Re: Paseo Vista Units A1, A2 and A3 plus reverses

The attached revision applies to Paseo Vista Units A1, A2 and A3 as well as the reverse plans for each. The bubbled areas were revised as follows:

PASEO VISTA
UNITS A1, A2, A3
1960 and 2290 DUTTON AVENUE
SANTA ROSA, CA

H1

PARTIAL LOWER CORE CEILING FRAMING PLAN

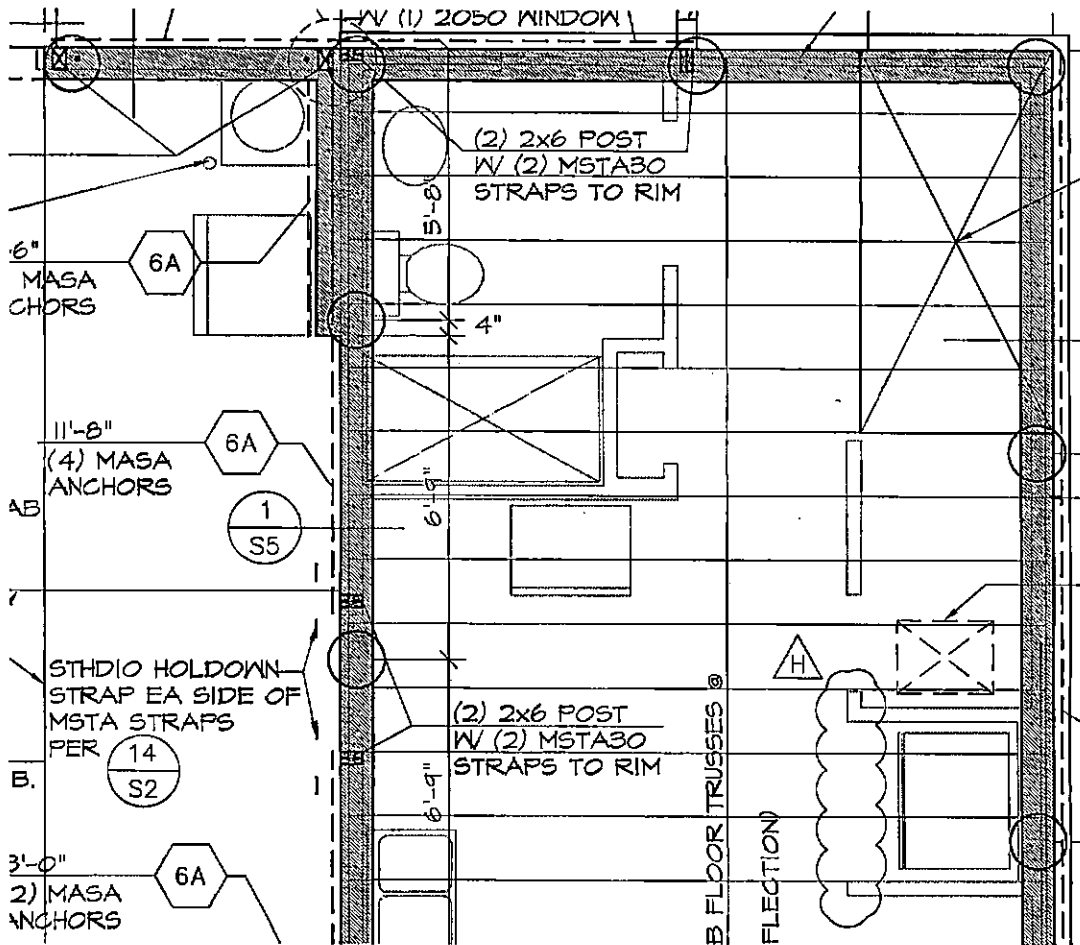
The door/header into the washing machine alcove has been removed and the washing machine has been moved to the garage and the refrigerator has been moved to the alcove. This revision has no structural impact.

H 3-18-19 FIELD REV	M.L.
------------------------	------
